STATE OF WASHINGTON
DEPARTMENT OF ECOLOGY

Subject: Van Stone Mine, Tailings Pond Dam; Dam Safety file no. ST 61-0608
Dam Safety Inspection, summary findings and required remedial actions

7. West Cell north side dam crest, looking downstream. Erosion damage above PVC liner.

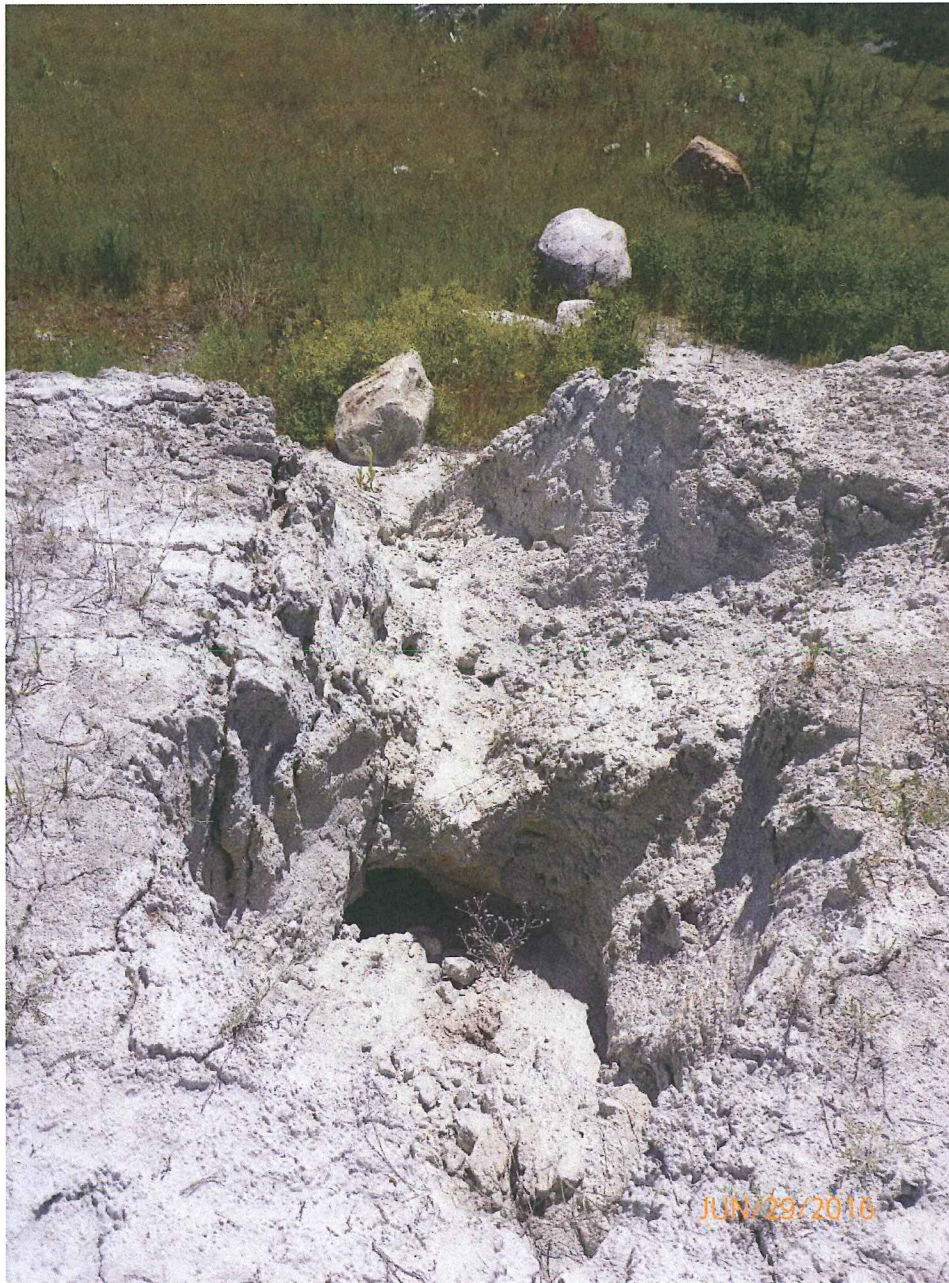
The embankment appears to be in similar condition as described in these previous reports, with similar deficiencies. The erosion damage to the embankment slopes should be repaired, and the slopes re-graded to a stable, smooth, even slope. In conjunction with this, an erosion-resistant cover or surface should be established or installed on the embankment slopes.

10. West Cell south side downstream face, looking downstream. Erosion damage includes piping.

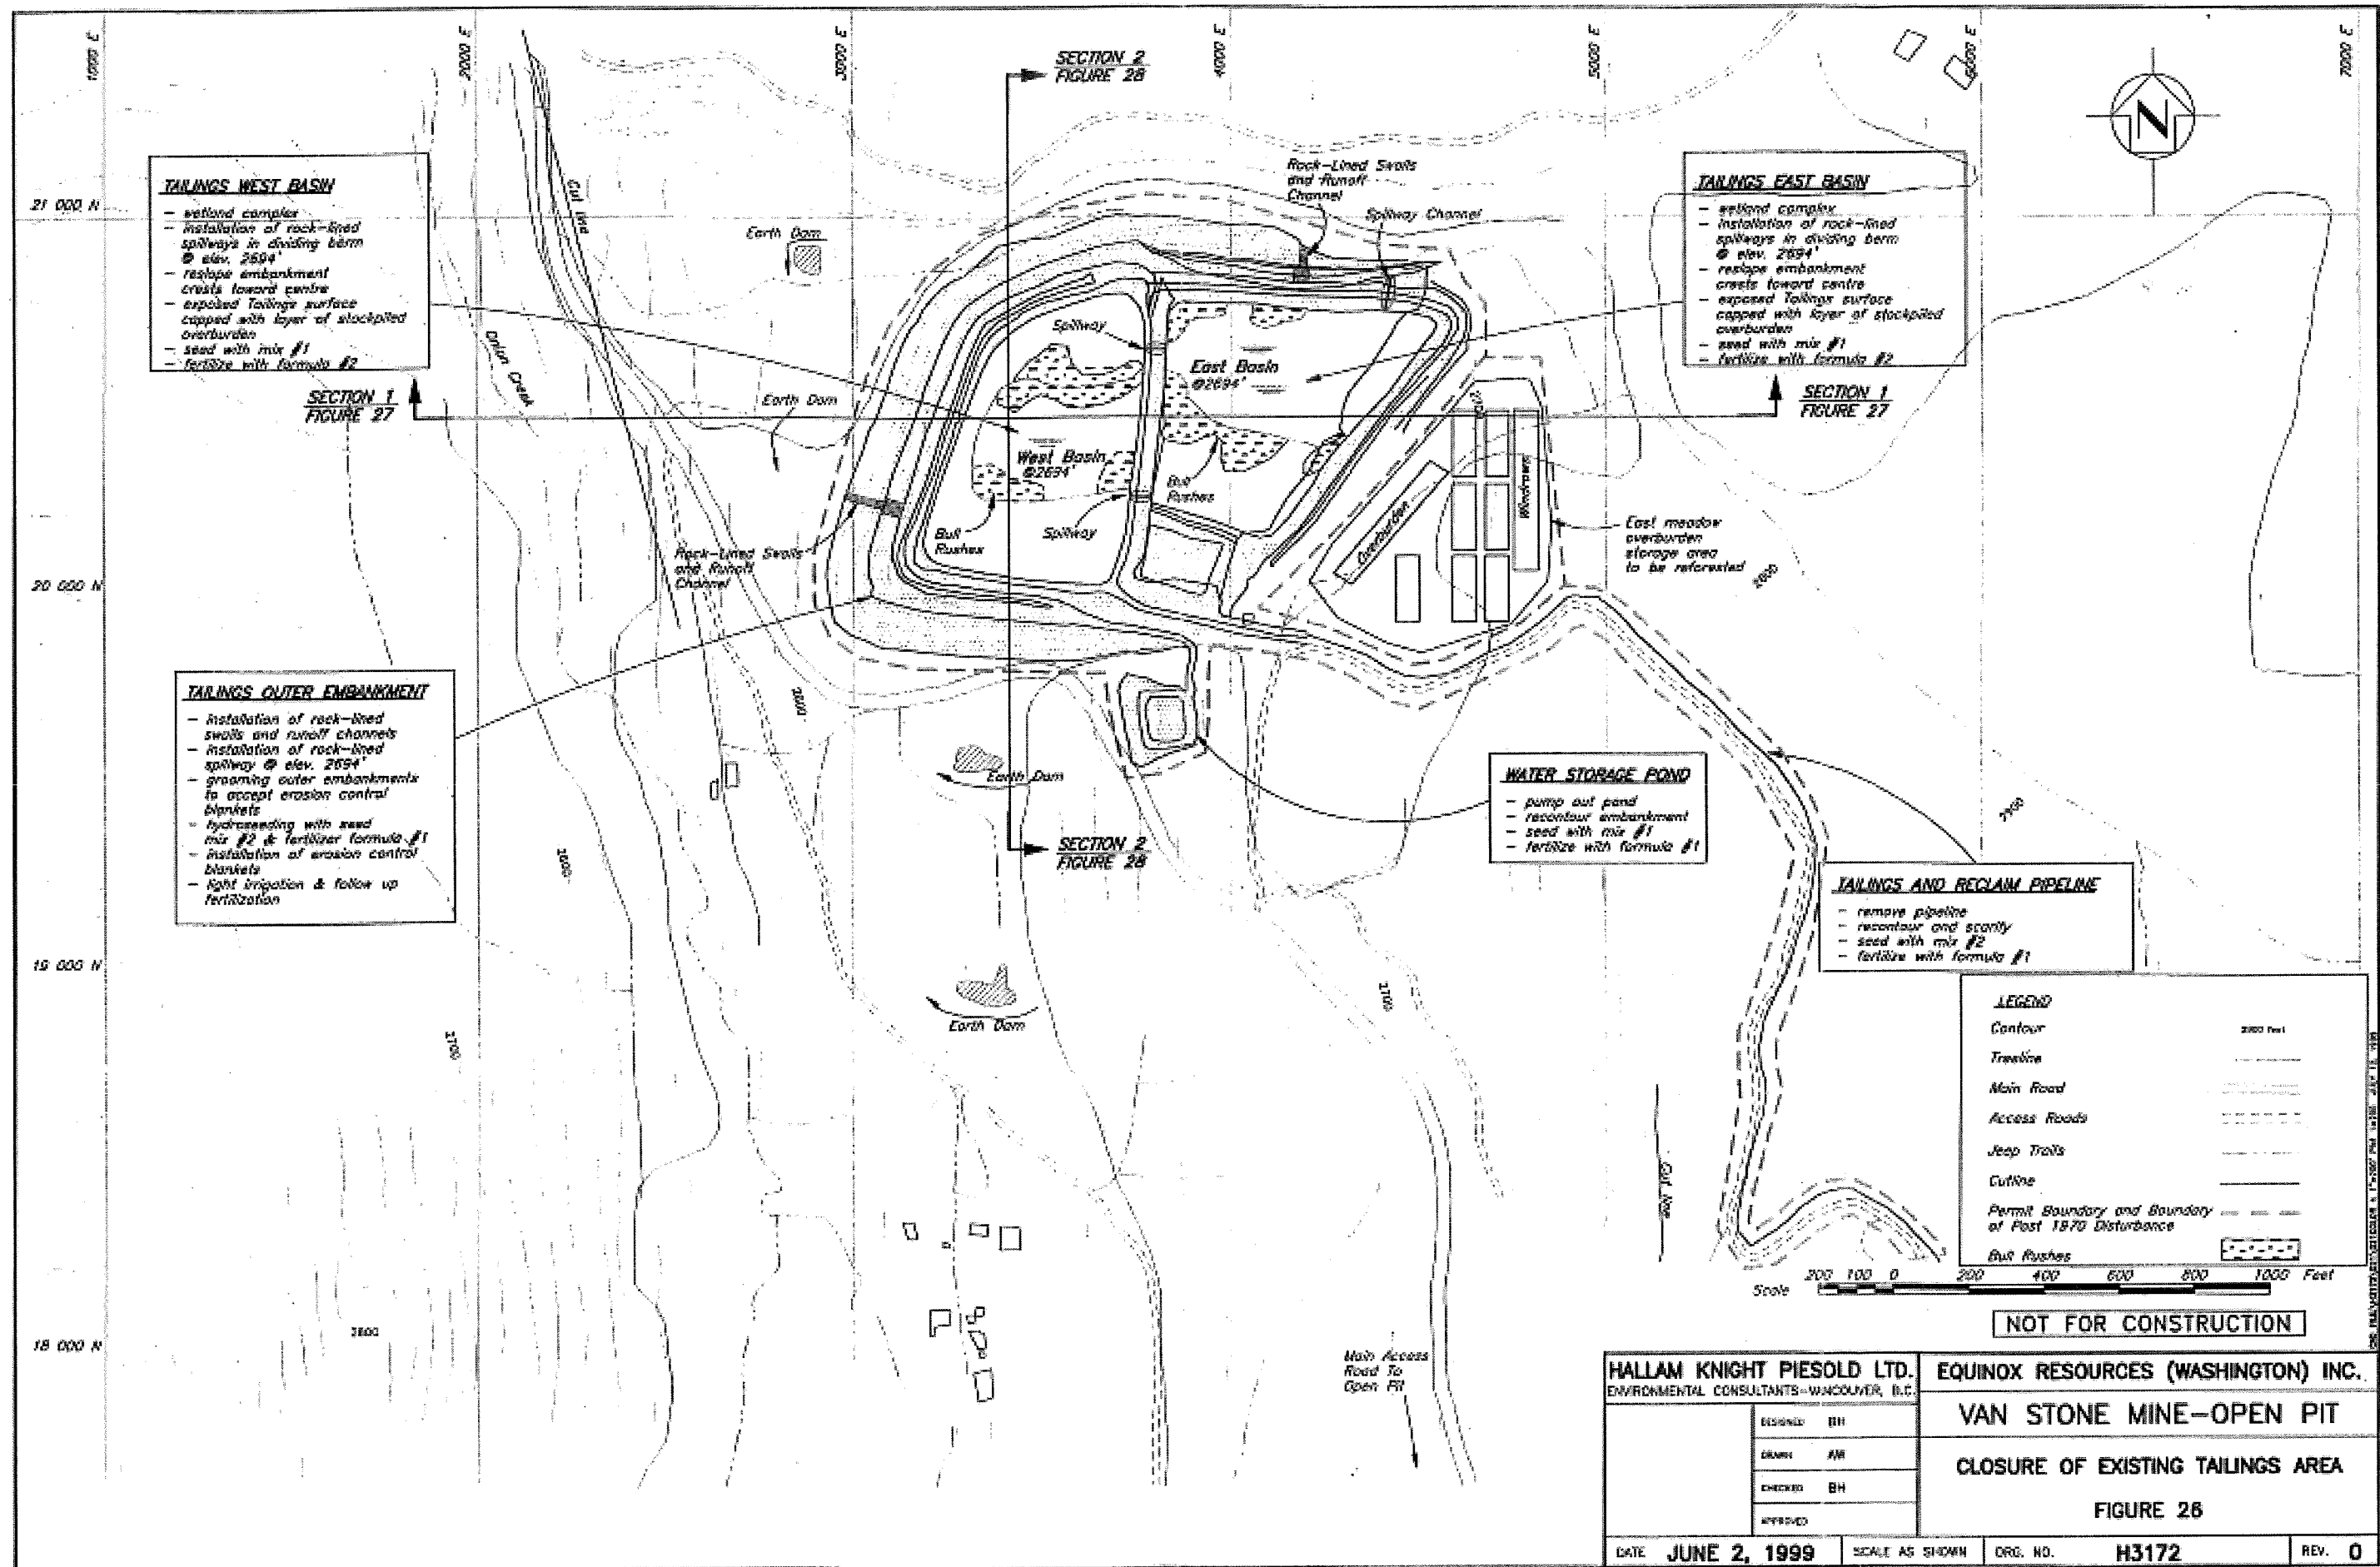
9. West Cell west side downstream face, looking right. Soil movement (slumping).

11. West Cell south side downstream face, looking downstream. Erosion damage includes piping.

HALLAM KNIGHT PIESOLD LTD. ENVIRONMENTAL CONSULTANTS-WANCOUVER, B.C.		EQUINOX RESOURCES (WASHINGTON) INC.	
DESIGNED: BH		VAN STONE MINE-OPEN PIT	
DRAWN: AW		CLOSURE OF EXISTING TAILINGS AREA	
CHECKED: BH		FIGURE 26	
APPROVED:		DATE JUNE 2, 1999	SCALE AS SHOWN
		ORG. NO. H3172	REV. 0

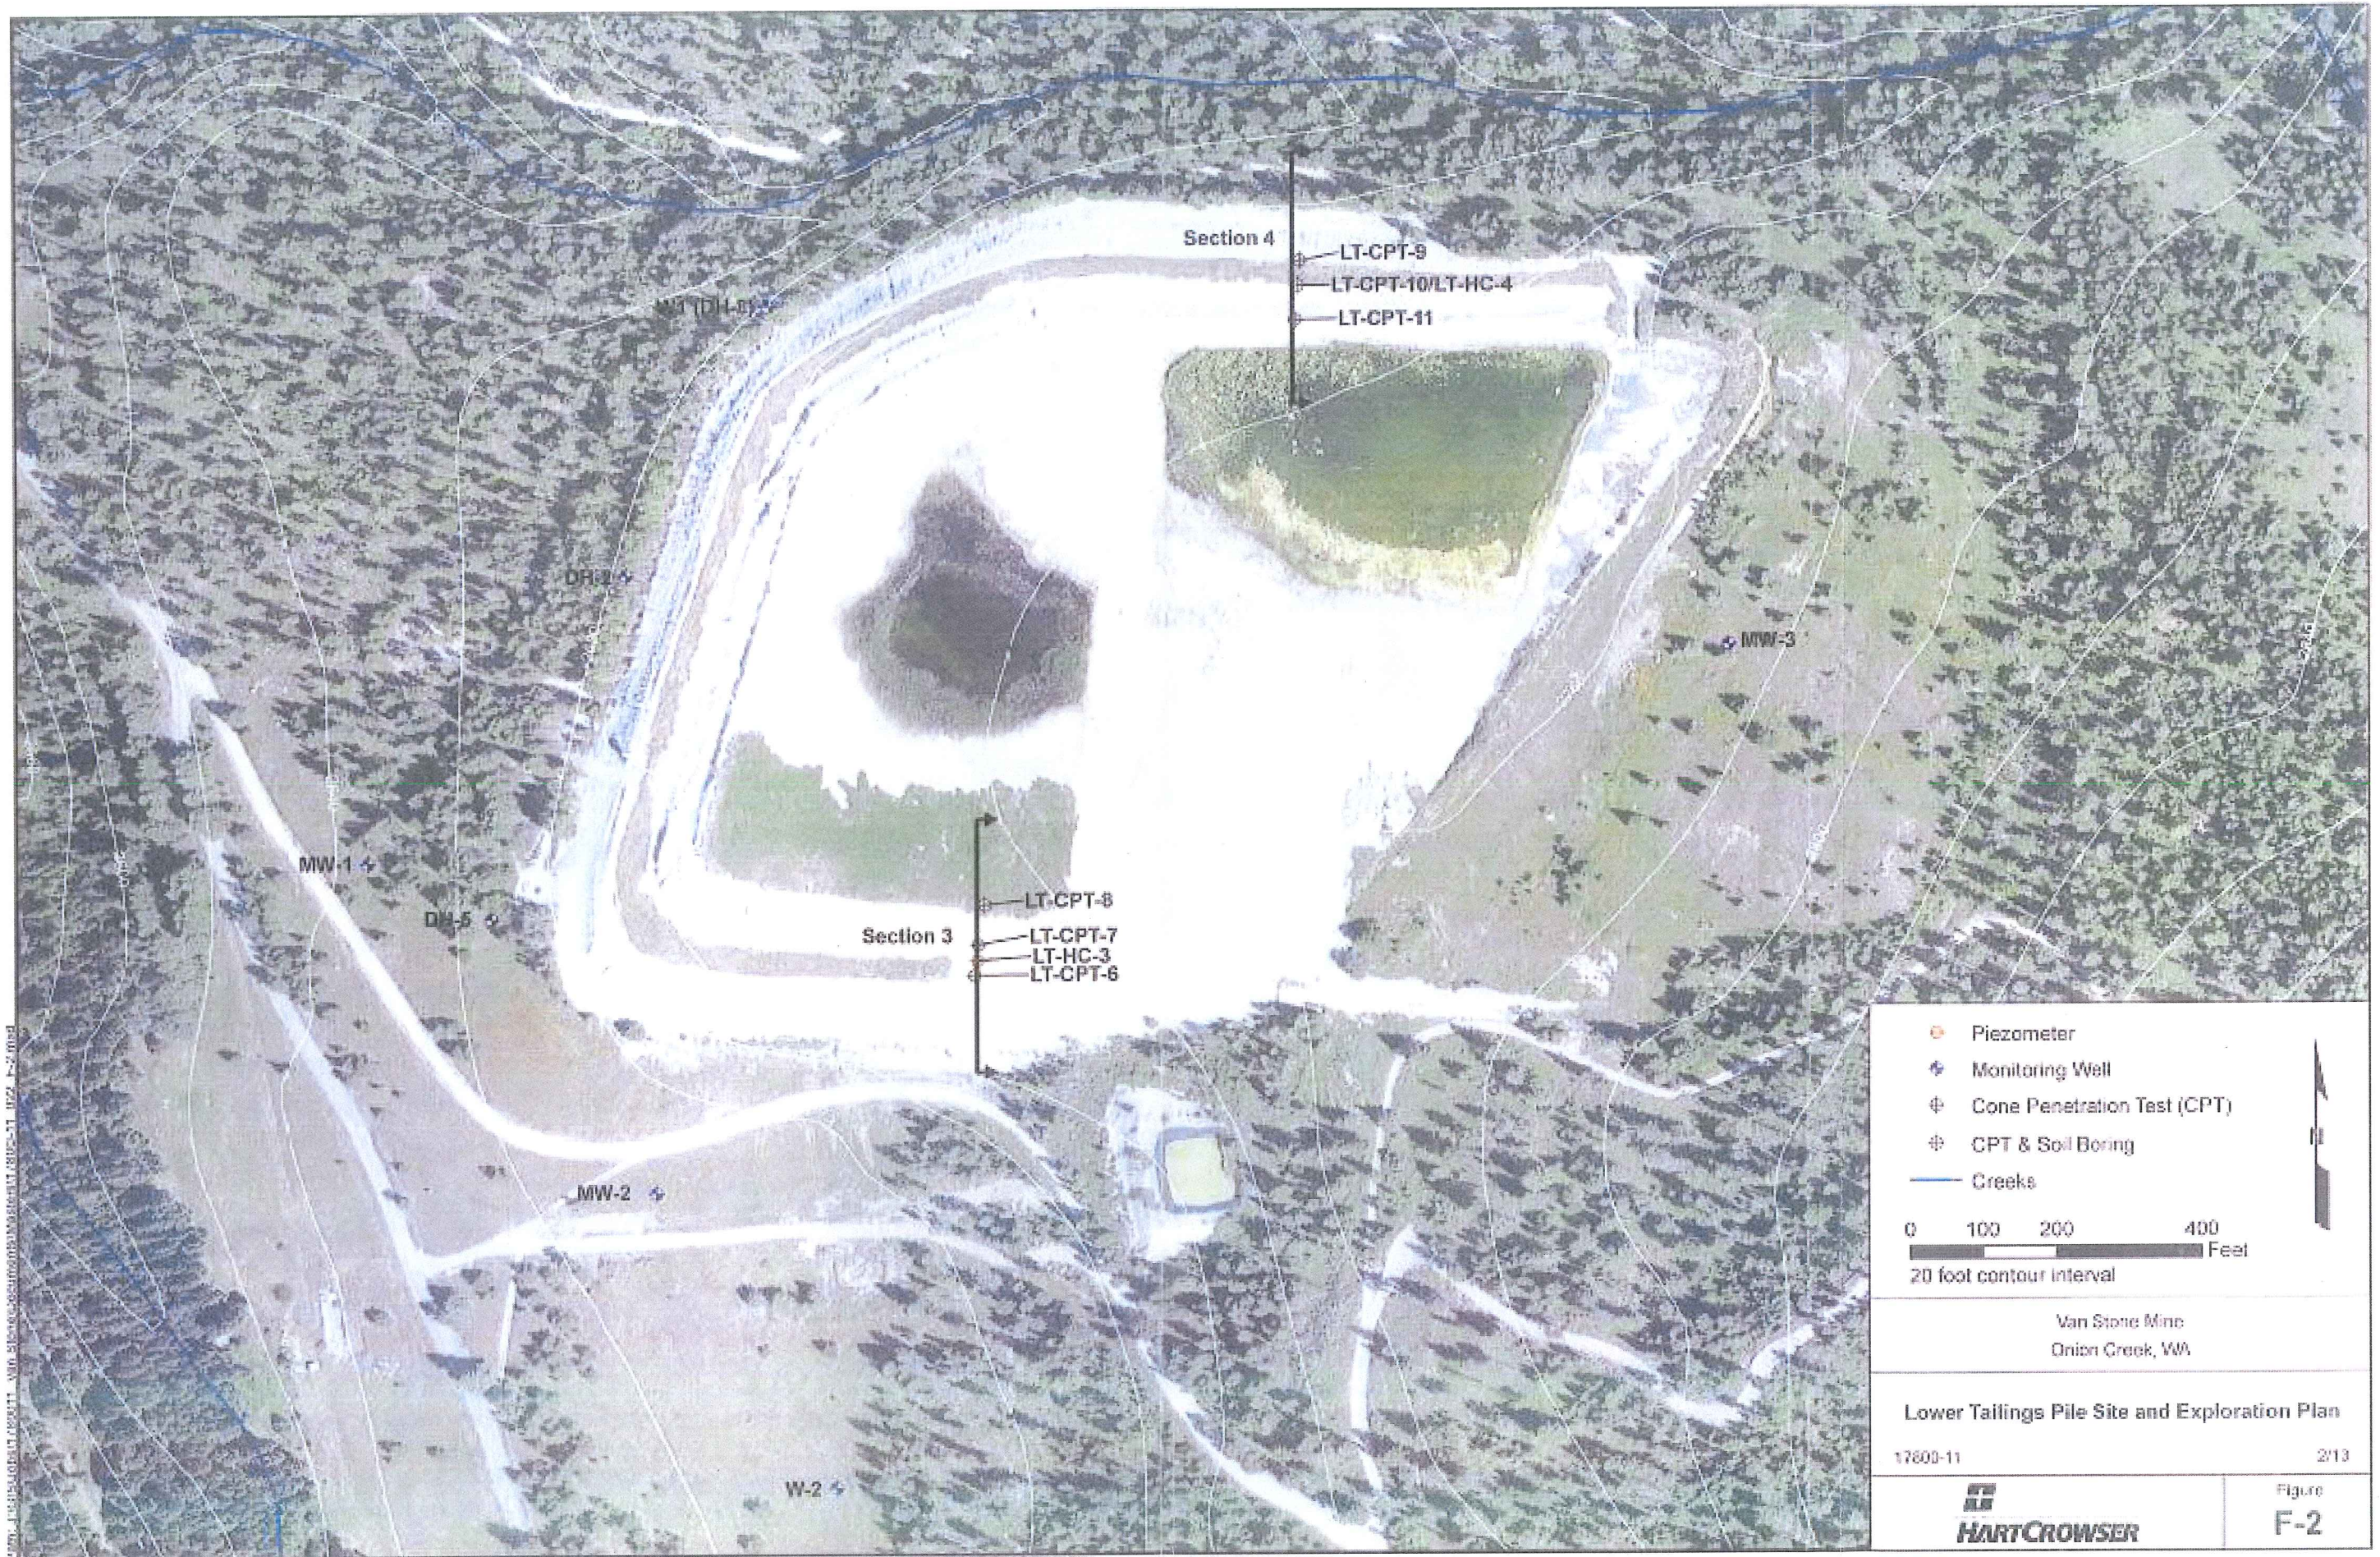
The Reclamation Plan by Beacon Hill Consultants (1999) in section 6.3.2 on page 16, and on Figure 26 by Hallam Knight Piesold Ltd, notes that the spillway should overflow at elevation 2694 feet. The previous inspection report (Ma and Blacklaw, 2008), on the project data sheet on page 6, lists a spillway base width of 6 feet.

The Reclamation Plan by Beacon Hill Consultants (1999) in section 6.3.2 on page 16, and on Figure 26 by Hallam Knight Piesold Ltd, notes that the spillway should overflow at elevation 2694 feet. Apparently only one of the two proposed equalizing spillways was actually installed. The previous inspection report (Ma and Blacklaw, 2008), on the project data sheet on page 6, lists a spillway base width of 6 feet, specifically for the overflow spillway but presumed to apply to the equalizing spillway also.

From a review of inspection photos from 2006, 2011 and 2016, it appears that sediment may have slumped into the spillway channel such that the spillway is no longer 6 feet wide at elevation 2694 feet. Any accumulated sediment should be removed to restore the spillway to the design geometry and overflow elevation. From elevation data for the East Cell north berm, it appears that the notch through the embankment may be around 9 feet deep at the spillway

From a review of inspection photos from 2006, 2011 and 2016, it appears that sediment may have slumped into the spillway channel such that the spillway is no longer 6 feet wide at elevation 2694 feet. Any accumulated sediment should be removed to restore the spillway to the design geometry and overflow elevation. From elevation data for the center berm, it appears that the notch through the embankment may be around 13 feet deep at the spillway location. From elevation data for the west berm, the notch through the center berm needs to be at least 3.5 feet lower than the lowest elevation on the west berm. After the spillway is re-opened, the erosion-resistant channel lining should be restored.
